001_Title Page

001_Title Page

Document Number:
PCB P/N:

Rev
005

CPLD_POWER

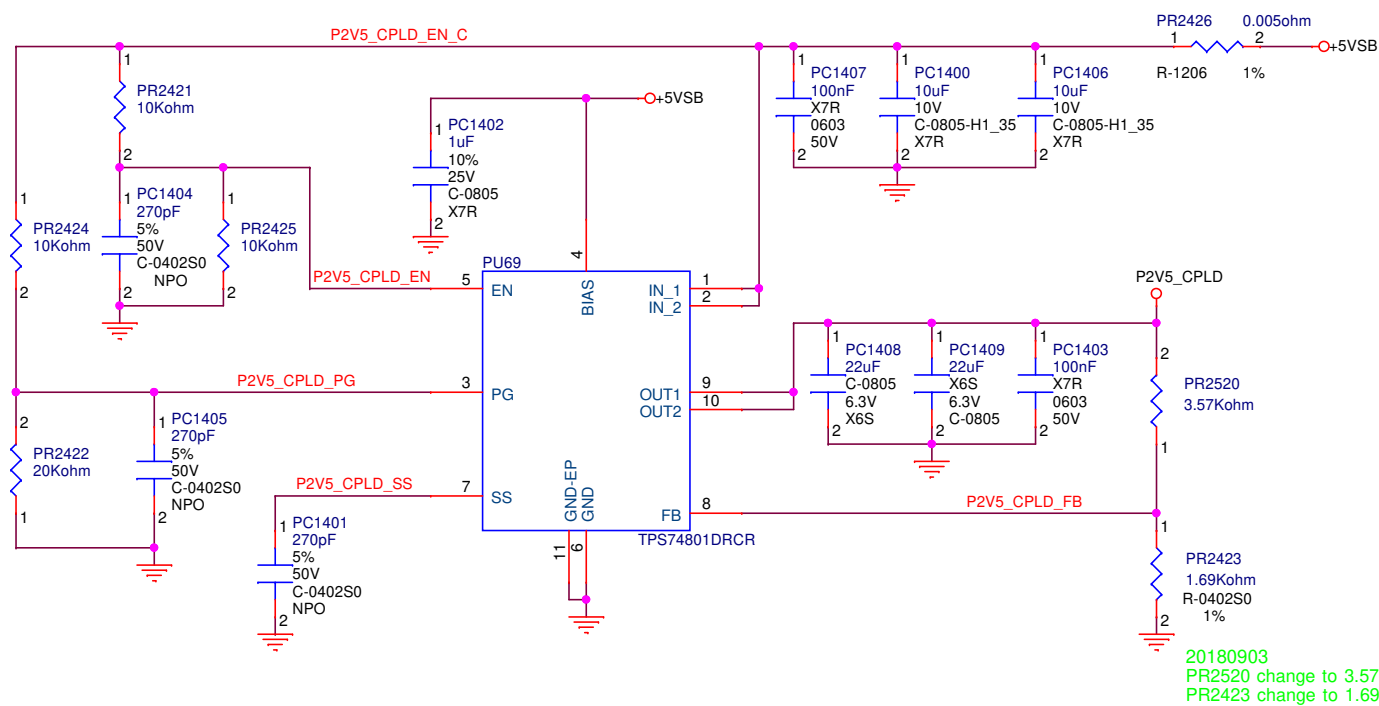
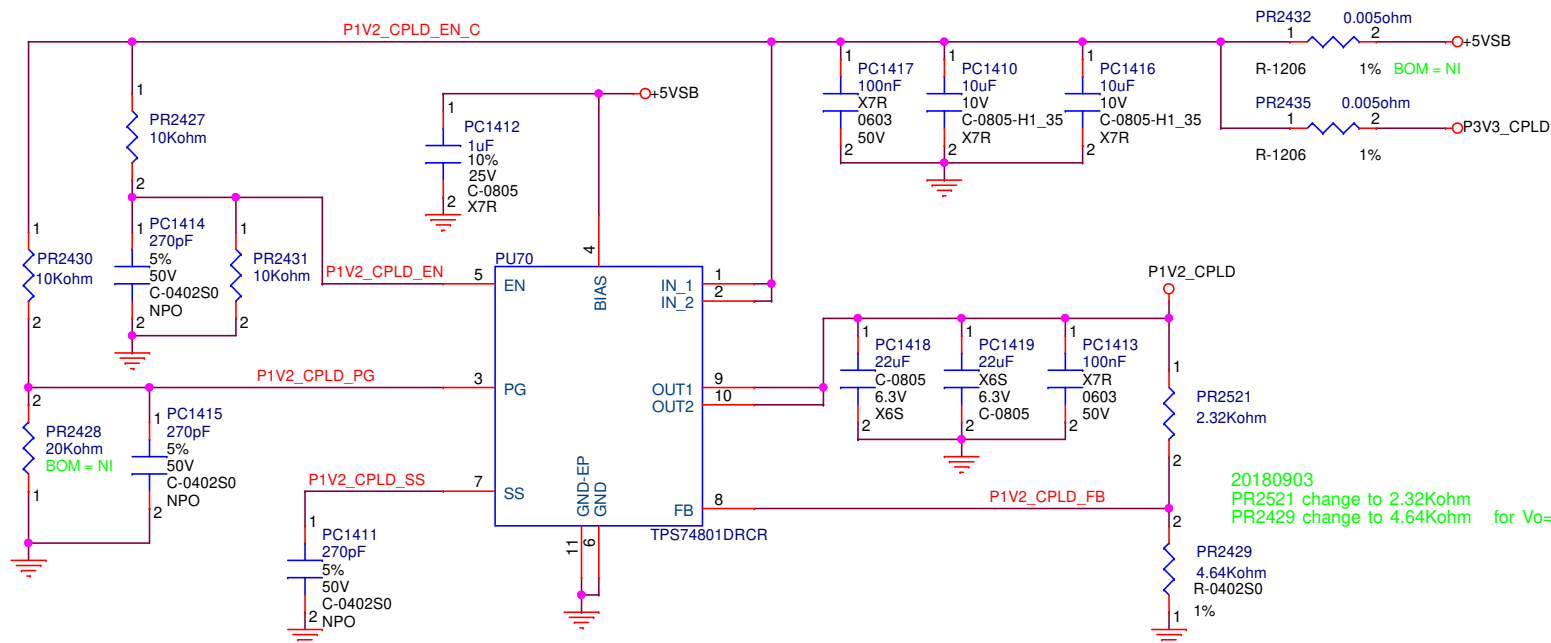
20180903
Insert PR302,PR2422

20180903
PR2520 change to 3.57Kohm
PR2423 change to 1.69Kohm for Vo=2.5V

20180903
PR2521 change to 2.32Kohm
PR2429 change to 4.64Kohm for Vo=1.2V
